# **Witek Park Field Improvements Derby, Connecticut**

**Environmental Review Team Report**

**for the  
Derby Inland Wetlands Agency  
Derby, Connecticut**

**January 2003**

Figure 4

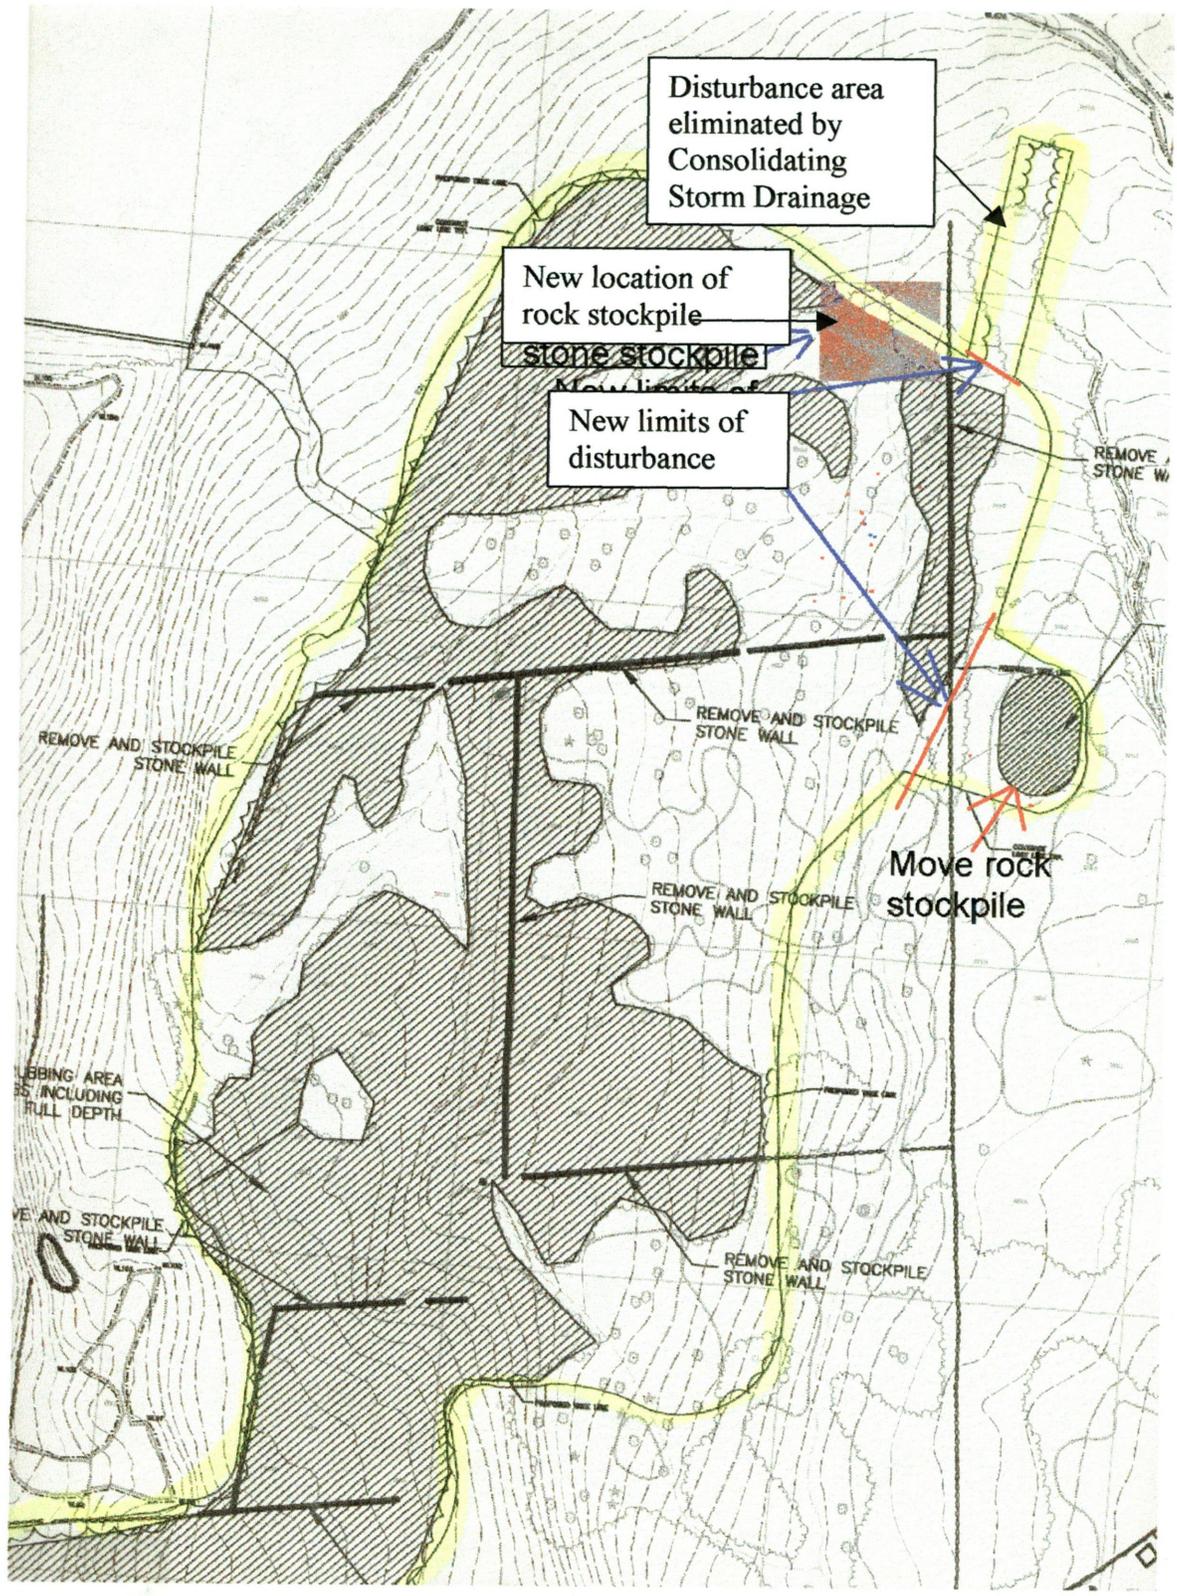
- *Relocate rock stockpile* to location more accessible after construction and to reduce disturbance near intermittent watercourse. Figure 4.
- *Minimize disturbance in the wetland buffer.* Particularly on the north side, the roadside disturbed area encroaches on the wetland buffer zone. Moving the roadway southward and decreasing the overall cleared margin would help minimize impacts to the buffer. Site line considerations for the access road could be mitigated by speed bumps or by increasing the curve radius which would be possible if the parking area were moved.

FIGURE 4 Relocate rock stockpile to location more accessible after construction and to reduce site disturbance near intermittent watercourse.

Figure 5

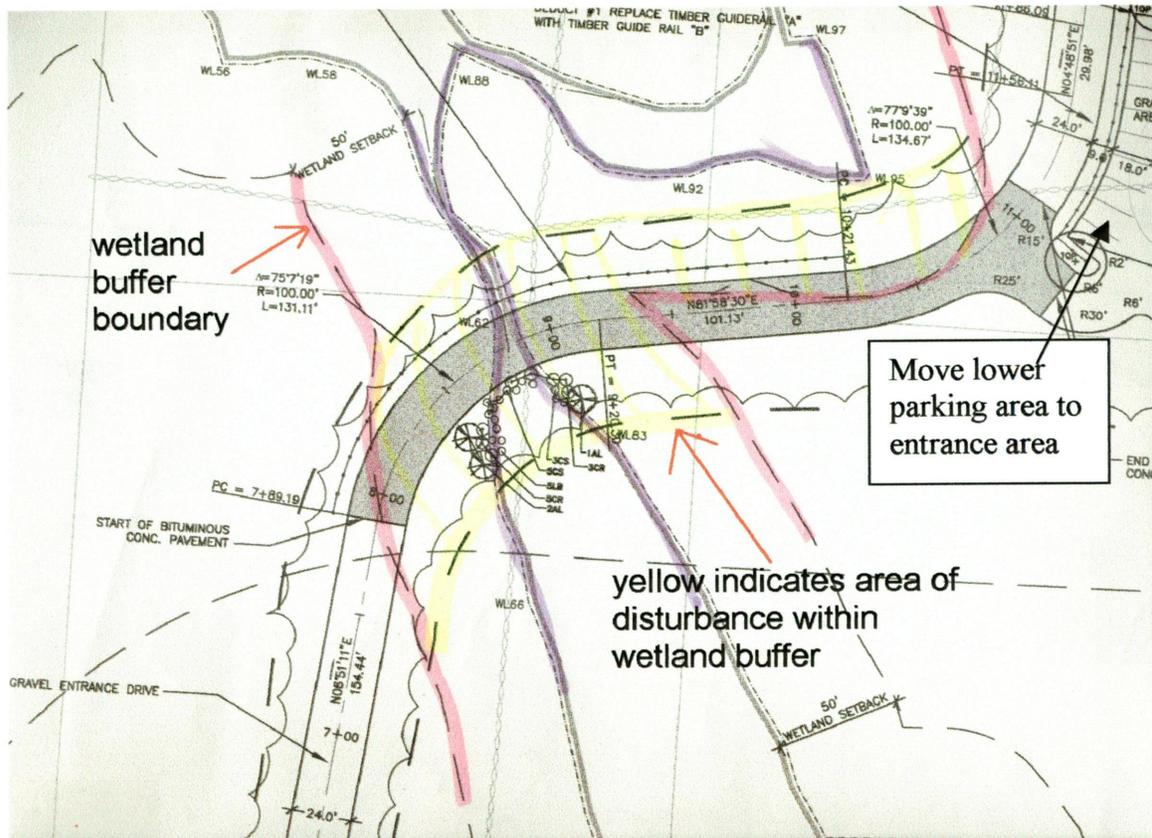
- *Move lower parking lot* closer to entrance area; lot can then be used for visitors to the memorial area and for other pedestrians accessing the park when access road is closed. Bringing the parking lot nearer to the entrance will decrease traffic on the access road and over the wetland crossing and reduce impermeable surfaces upslope of wetlands. Figure 5.

**FIGURE 2 Disturbance In The Wetland Buffer.** Particularly on the north side, the road side disturbed area encroaches on the wetland buffer zone. Moving the roadway southward and decreasing the cut vegetation margin would help minimize impacts to the buffer. Site line considerations for the access road could be mitigated by speed bumps or by increasing the curve radius that would be possible if the parking area were moved.

Figure 6

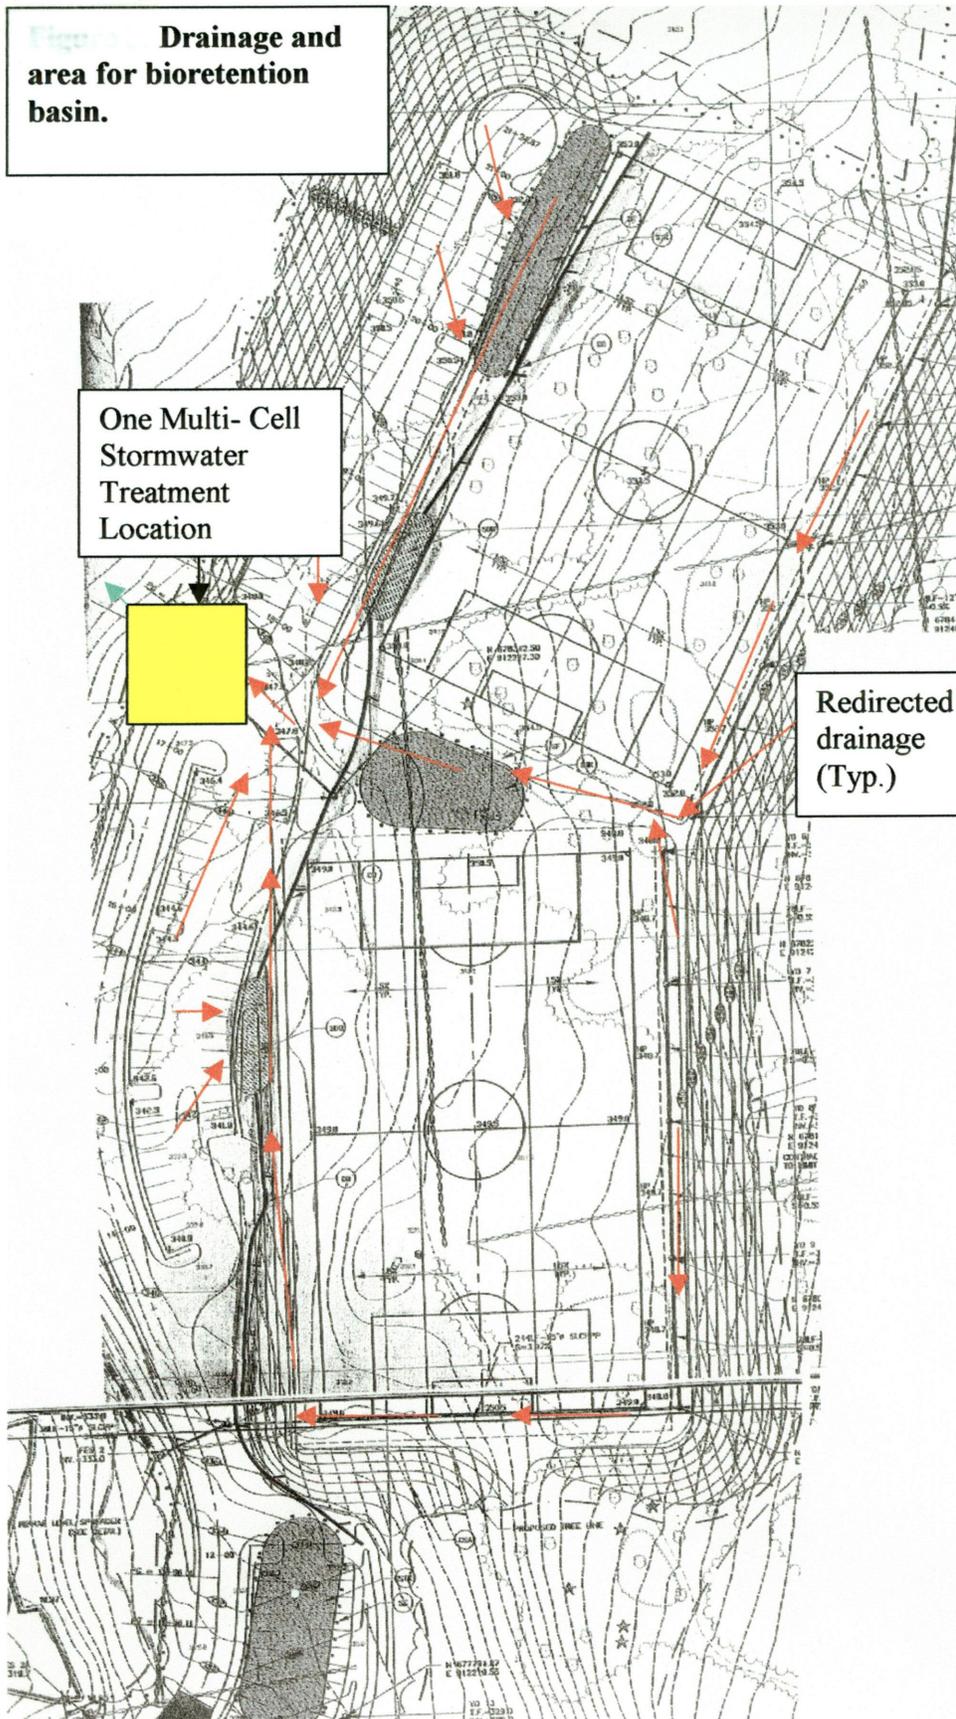
- *Redirect drainage system* for parking areas and recreational fields similar to Figure 6, to accommodate a single location for bioretention of runoff. Consider a system adaptable for use of stormwater for irrigation or for supplementing irrigation (Figure 7) and a structure which is designed and located for easy maintenance. The bioretention design should act to filter and to collect runoff for irrigation and or to retain for transpiration/evaporation, as opposed to favoring infiltration. Appendix B details bioretention design.
- *Show a plan for potable water and sanitation facilities* or include information in the application that demonstrates there is no need for such facilities. Any facility proposed would require careful design and design, given the extent and distribution of marginal soils on the site.

Figure 9

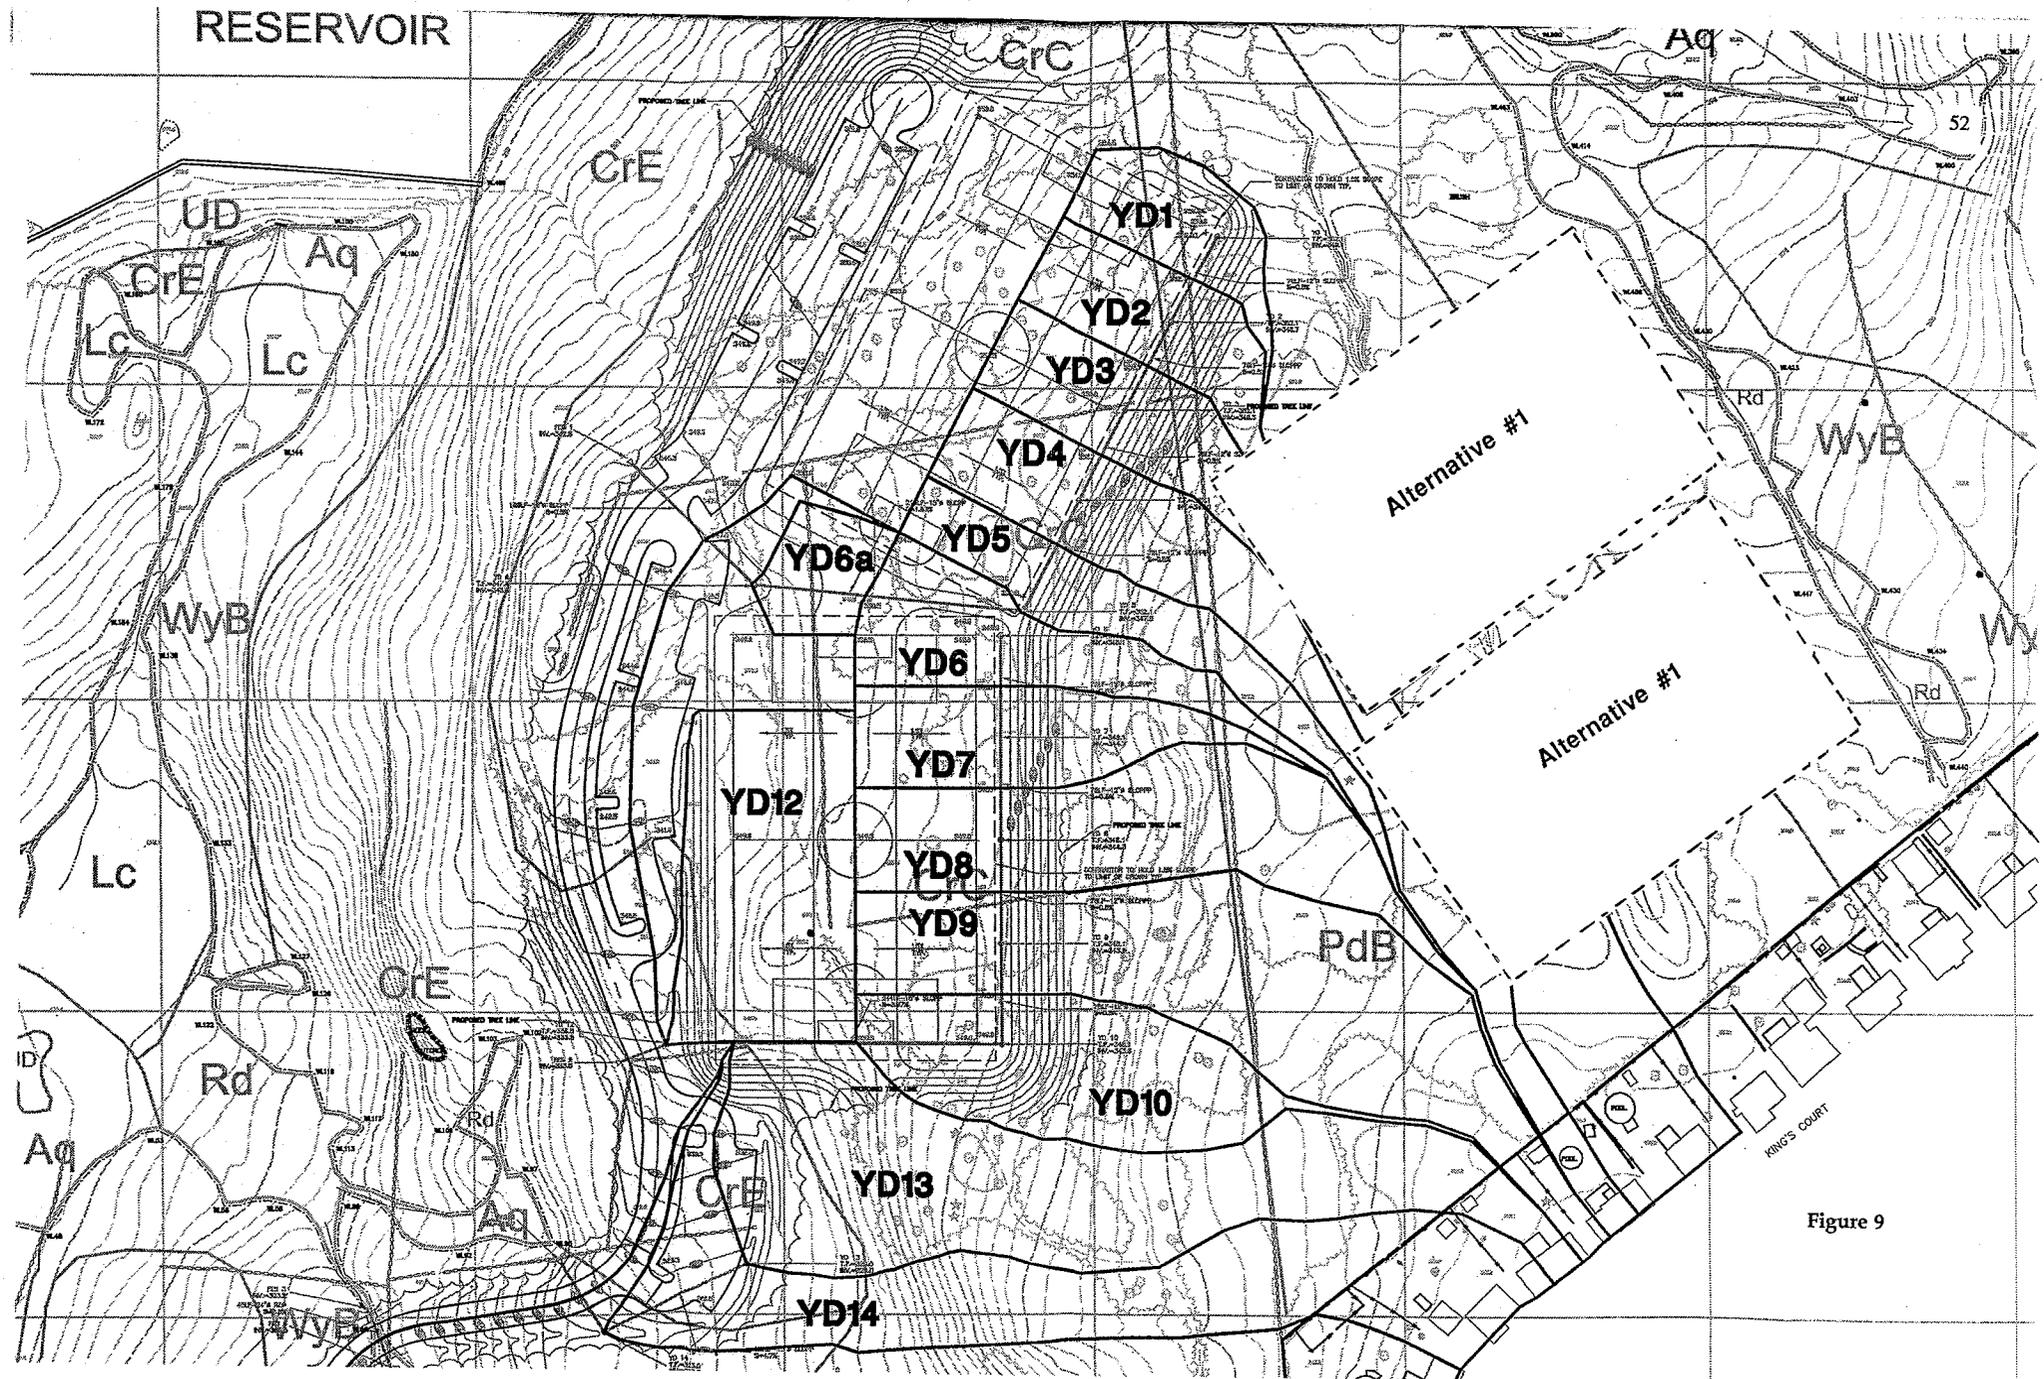
1. Figure 10 would involve two northwest-southeast running fields on either side of the storm drainage ditch and parallel with it. Admittedly the western field would impact a stonewall along its western periphery.
2. Figure 9 would involve piping the storm drainage ditch which is not a natural streamcourse or wetlands and allow two parallel northeast-southwest running fields. The design would allow maximum use of the most level acreage in the park and avoid impact on the stone wall mentioned in alternative above.
